LIFT STATION #2 STRUCTURAL MODIFICATIONS PROJECT NO. 800 402 01

City of Tukwila
LIFT STATION #2 STRUCTURAL MODIFICATIONS
PROJECT # 800 402 01

ADDENDUM NO. 1
Issued March 13, 2025

1 MOTOR AND CONTROL ROOM DEMO PLAN
S100 1/2"=1'-0"

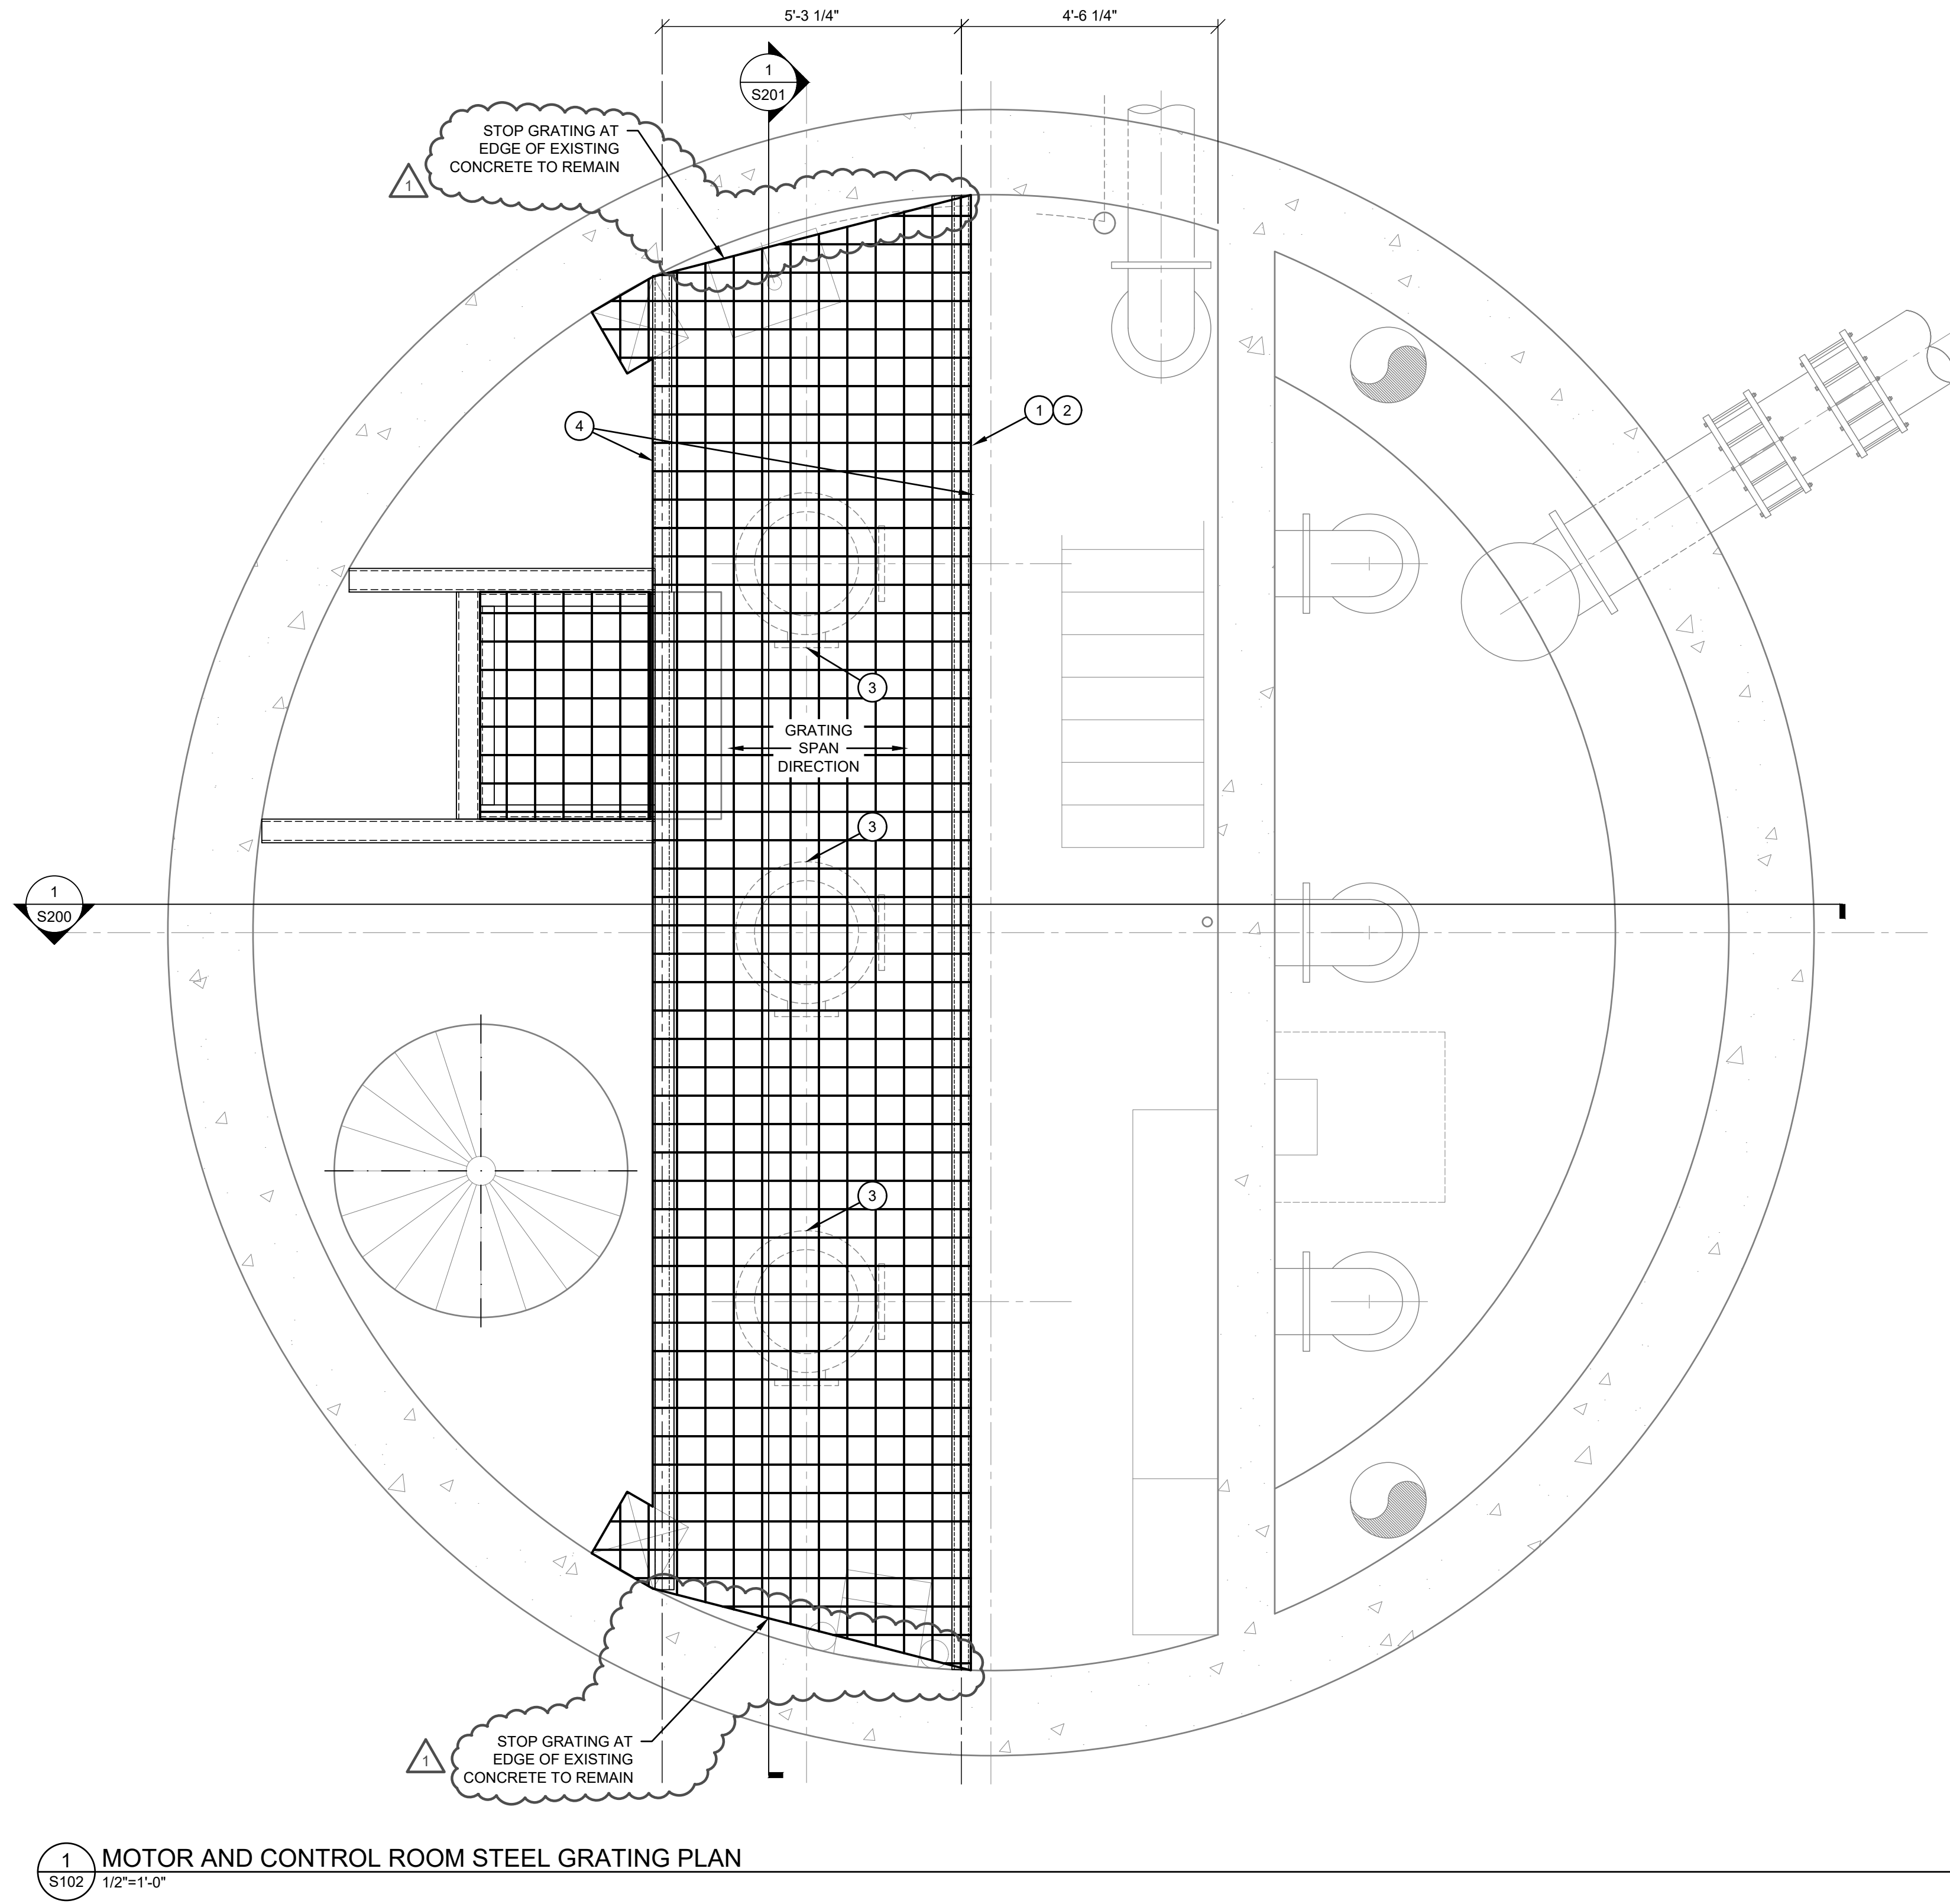
2. Sheet S100
 - a. Edge of concrete slab cut revised to be squared off. Cut edge does not need to go to rounded edge of lift station wall.
3. Sheet S102
 - a. Extent of steel grating revised to stop at squared edge of concrete slab cut.
4. Sheet S103
 - a. Revised note to state that existing 4'x4' double leaf door to remain.
 - b. Revised to include single leaf access door to be replaced. New Single leaf door to be by Bilco or approved equal.

5. Q: For the floor cut to install the beam, should the cut extend fully to the rounded edge, or can it be squared off?
A: *The cut for the slab demo can be squared off.*

1 VAULT LID PLAN
S103 1/2"=1'-0"

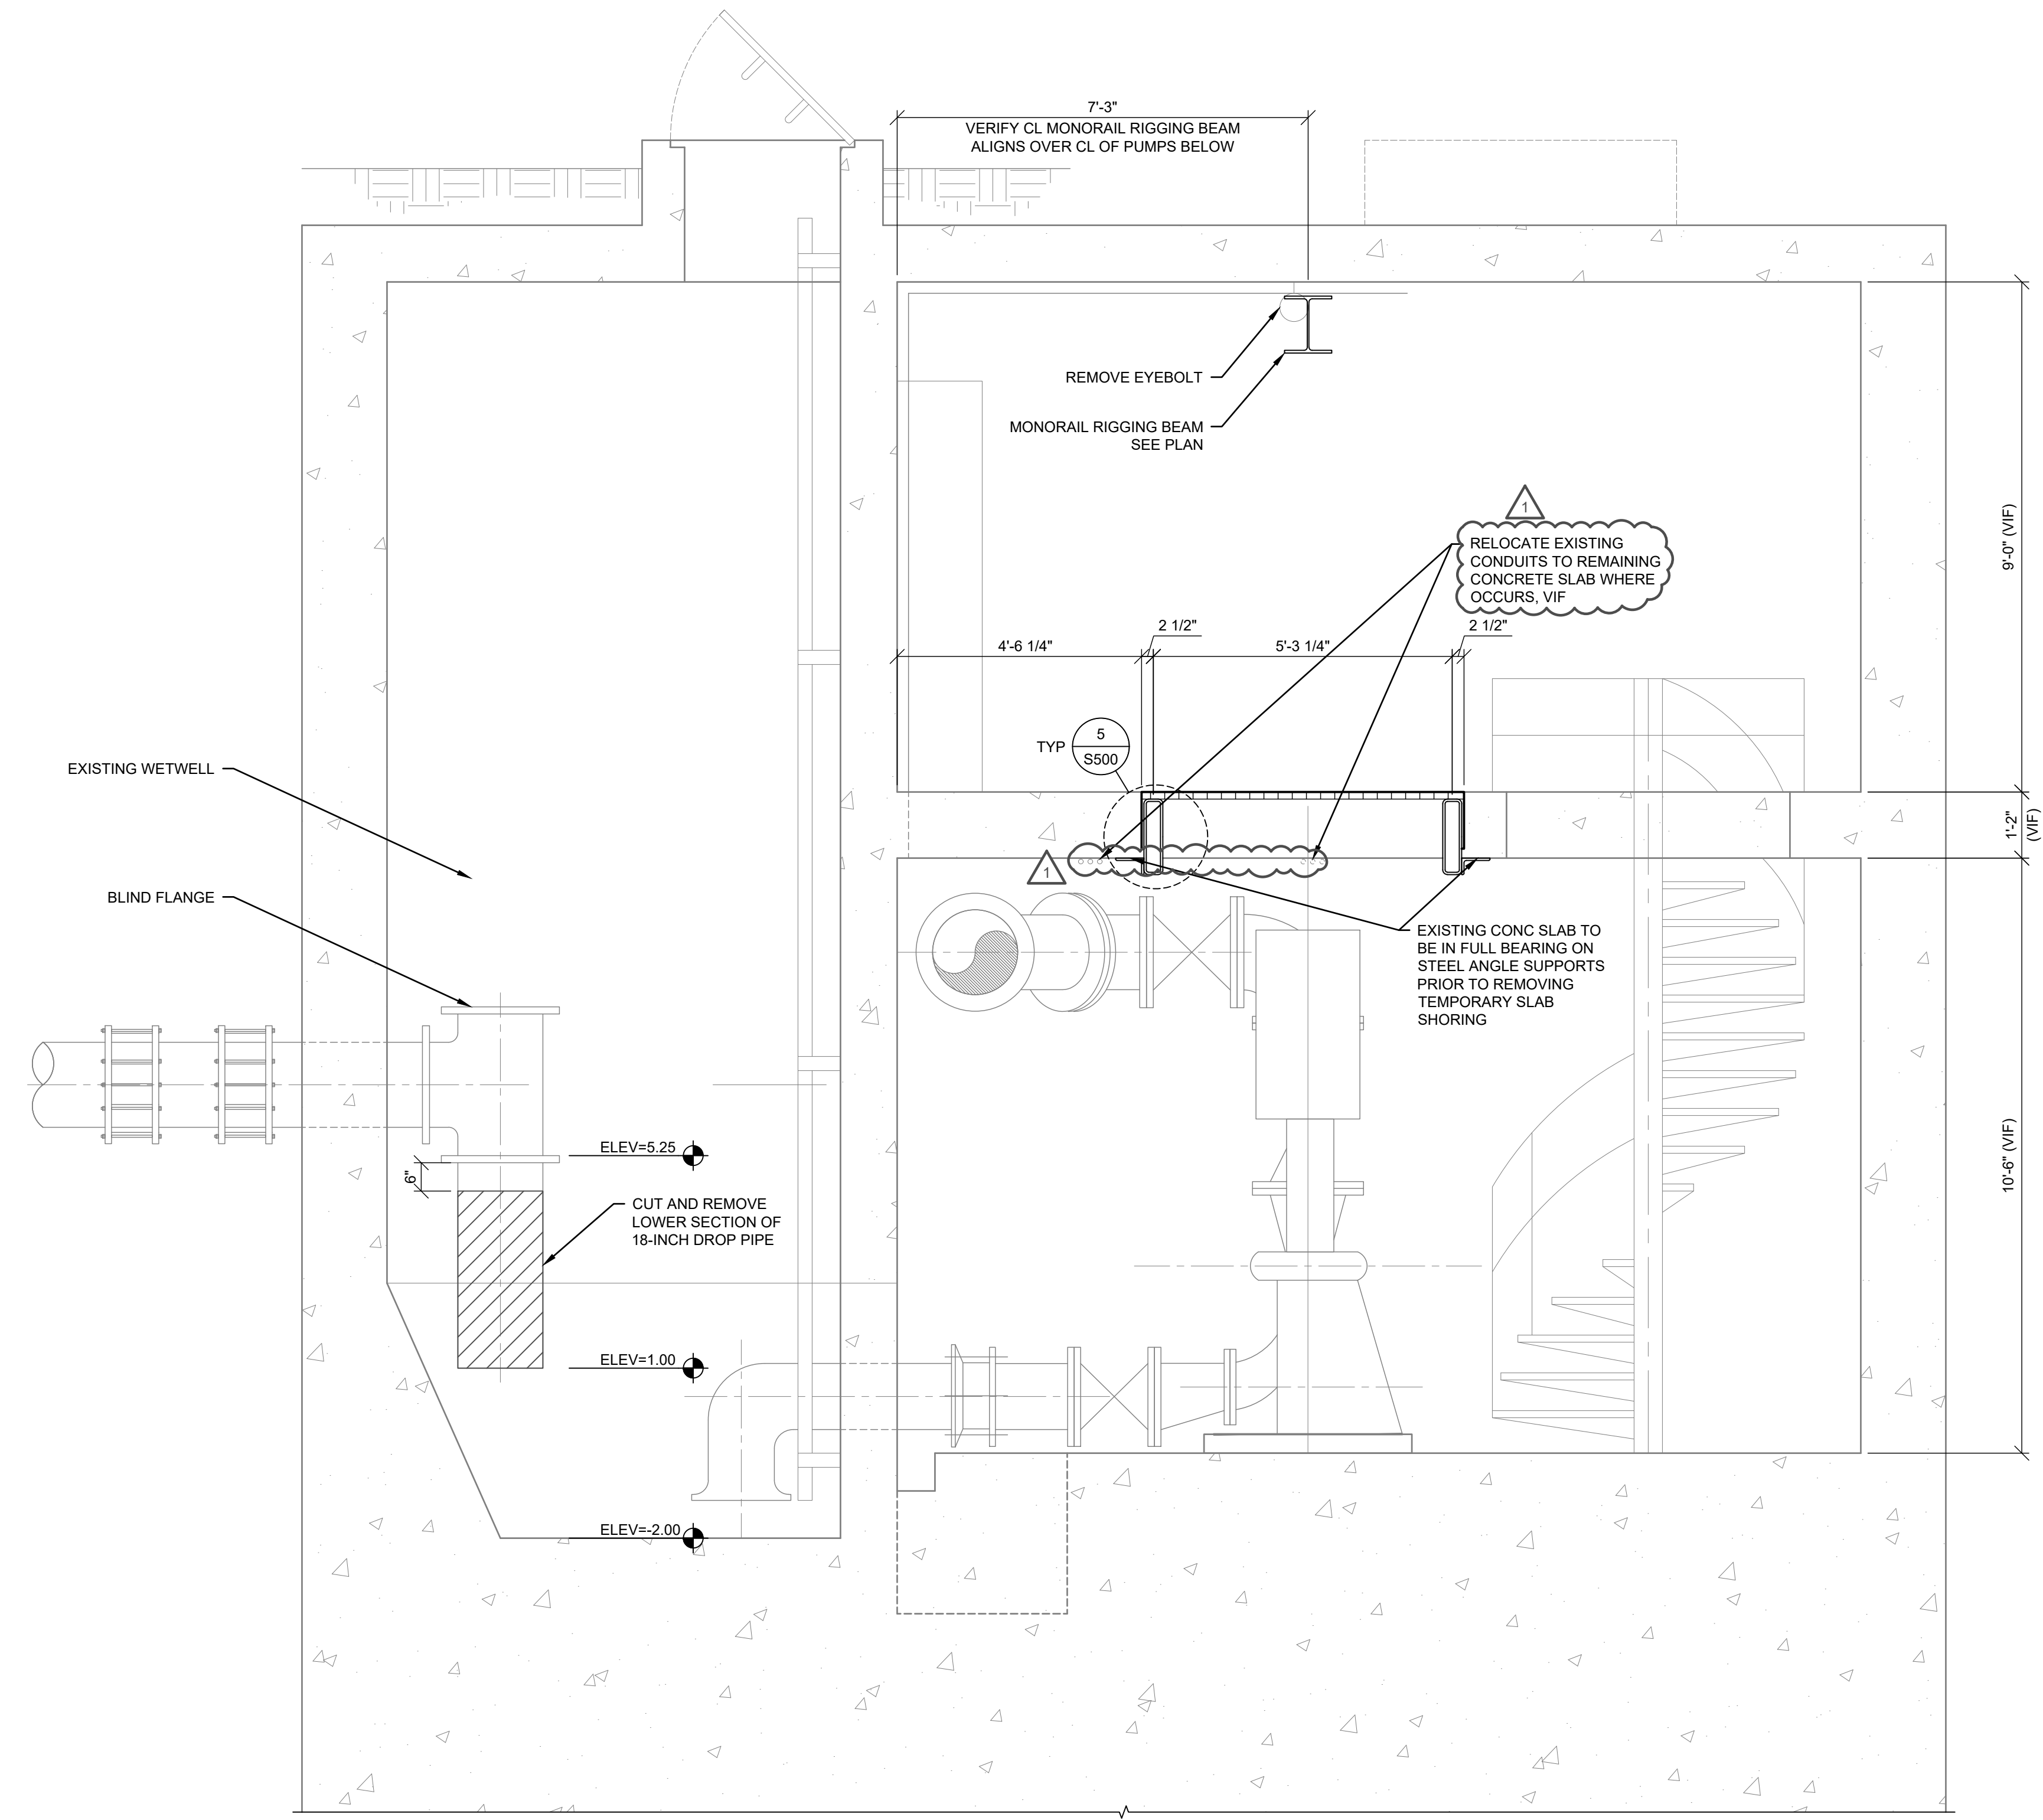
10. The bid documents incorrectly specify replacing the 4x4 hatch.

A: *The correct requirement is to replace (and possibly realign) the main entrance hatch of the lift station. See Sheet S103.*

1 STRUCTURAL SECTION & WETWELL TEE MODIFICATION
S200 1/2"=1'-0"

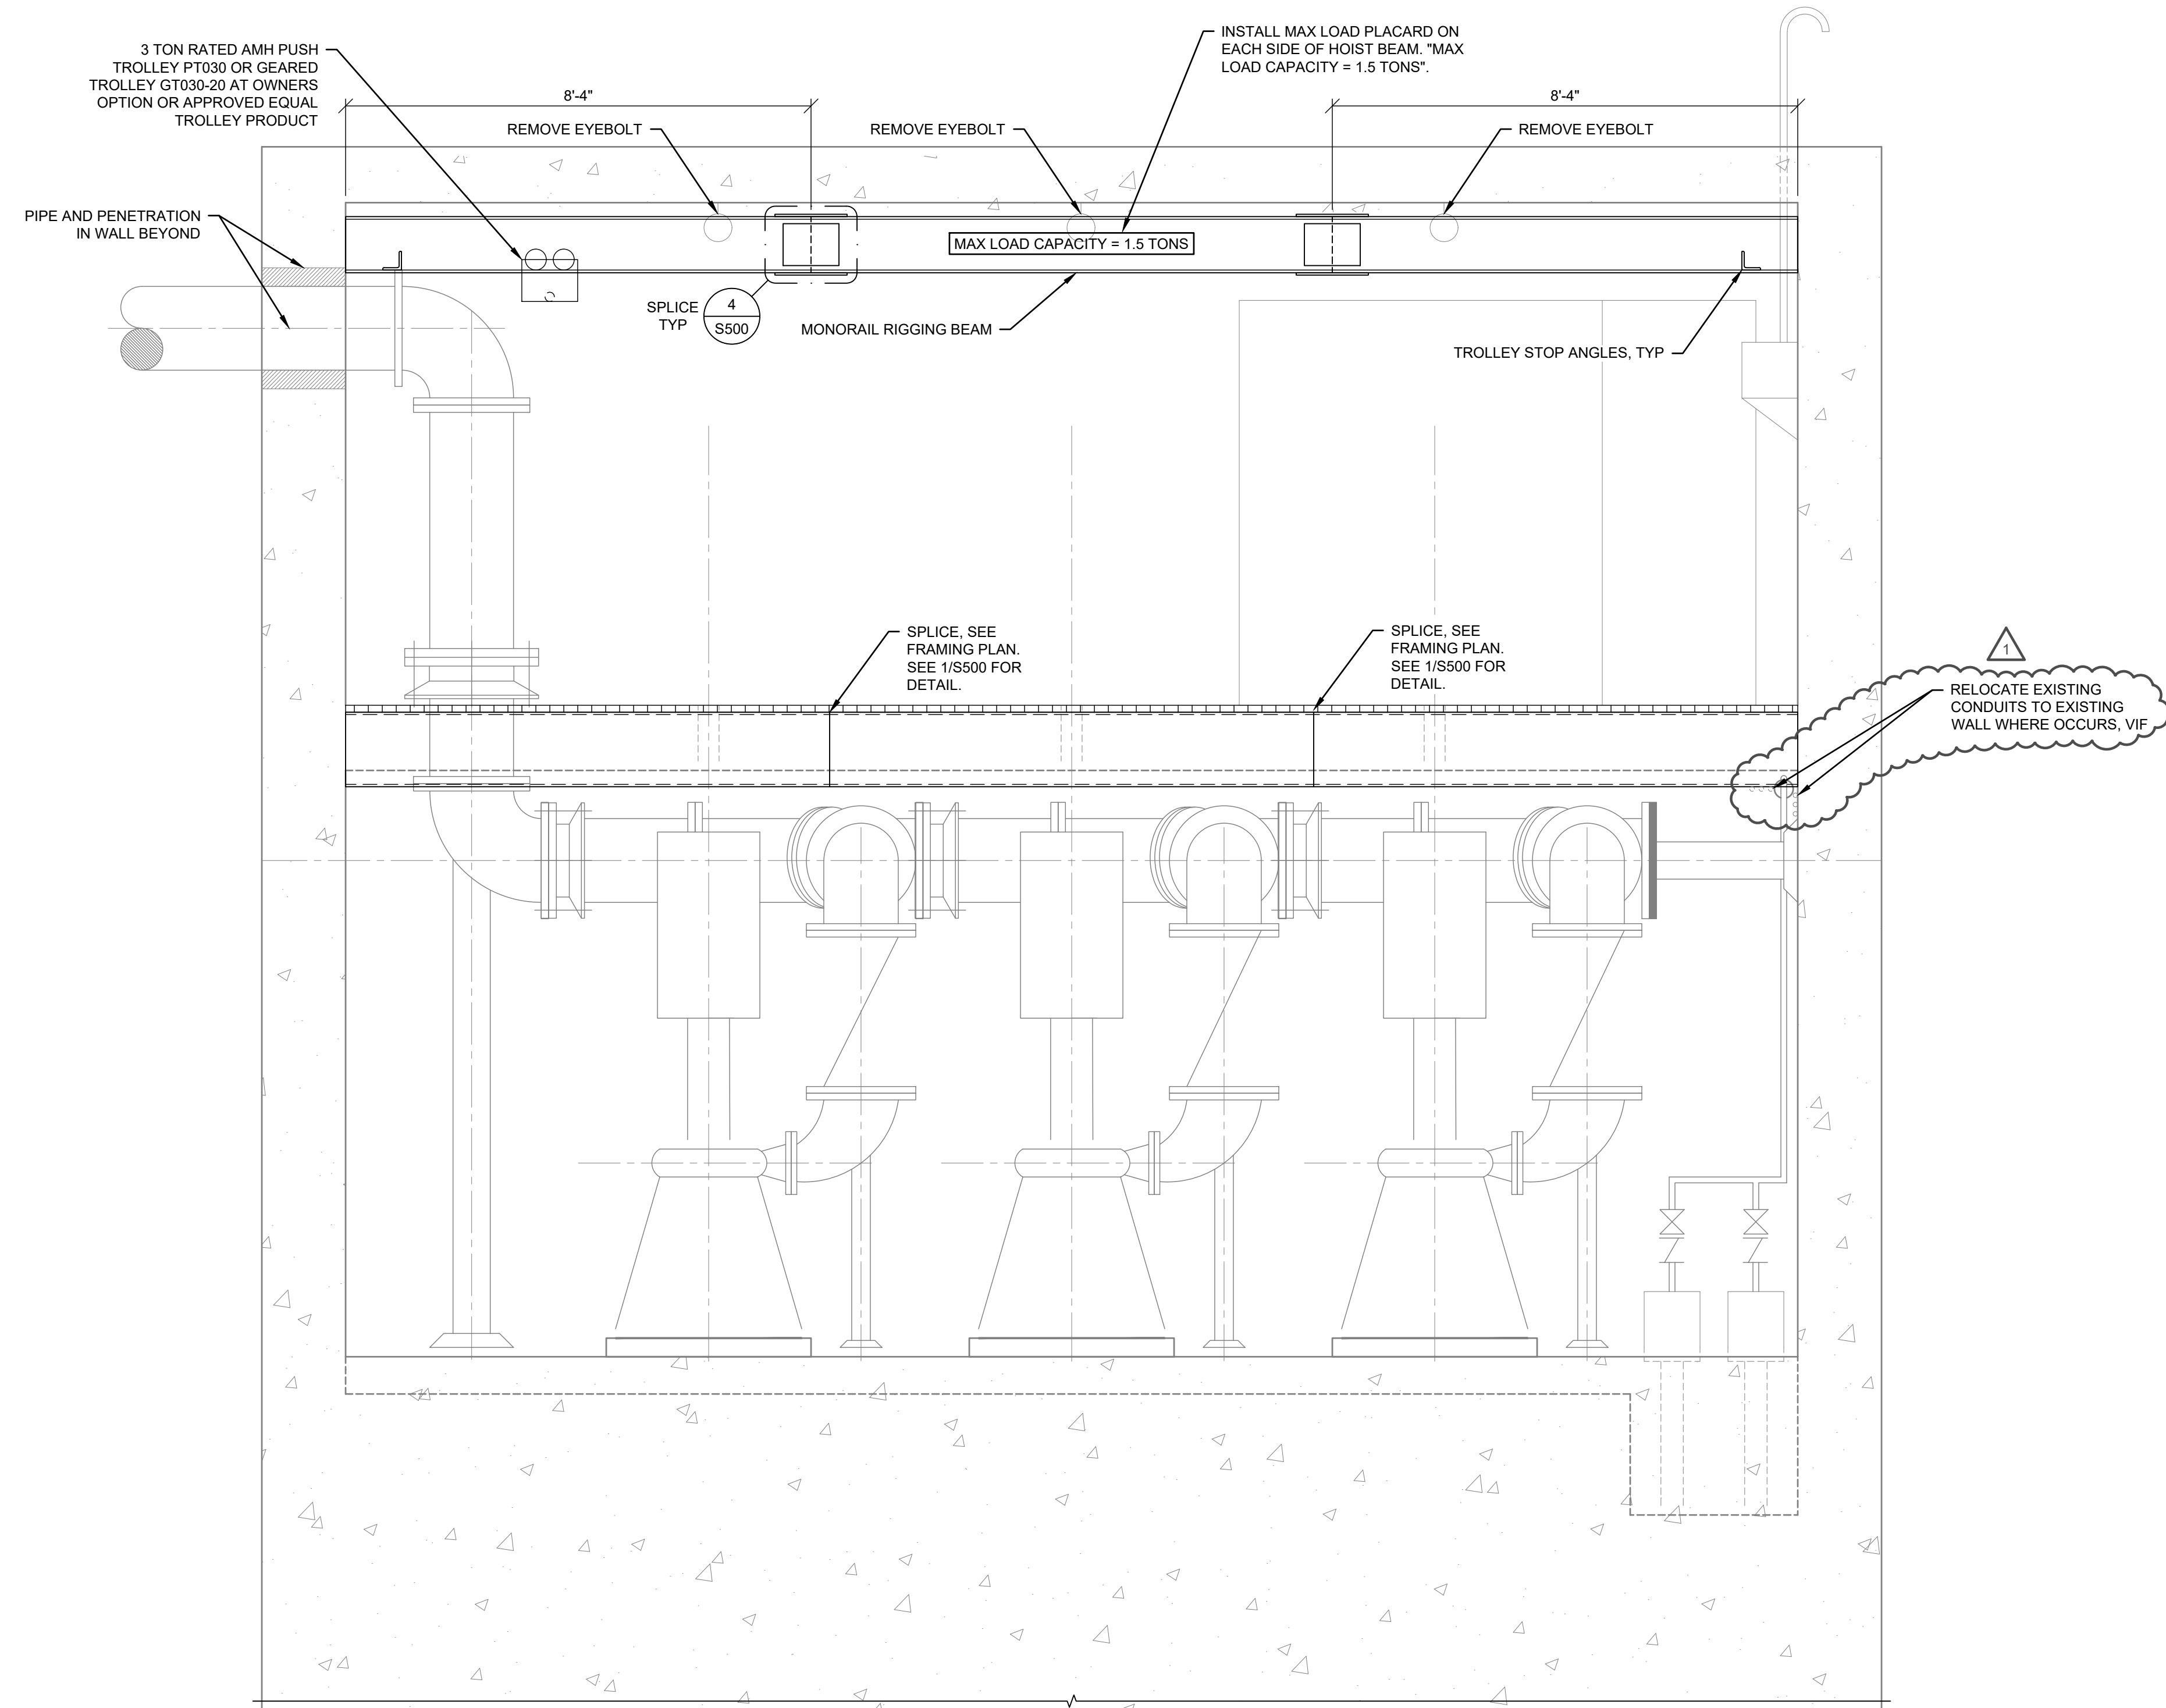
5. Sheet S200
 - a. Revised to include note for contractor to relocate any existing conduit away from concrete slab to be removed.
6. Sheet S201
 - a. Revised to include note for contractor to relocate any existing conduit away from concrete slab to be removed.

4. Q: There are conduits in the way, but no electrical sheets or clear notes.
A: *The contractor shall relocate the conduits to the nearest wall to avoid concrete demotion and accommodate the new steel support beams.*
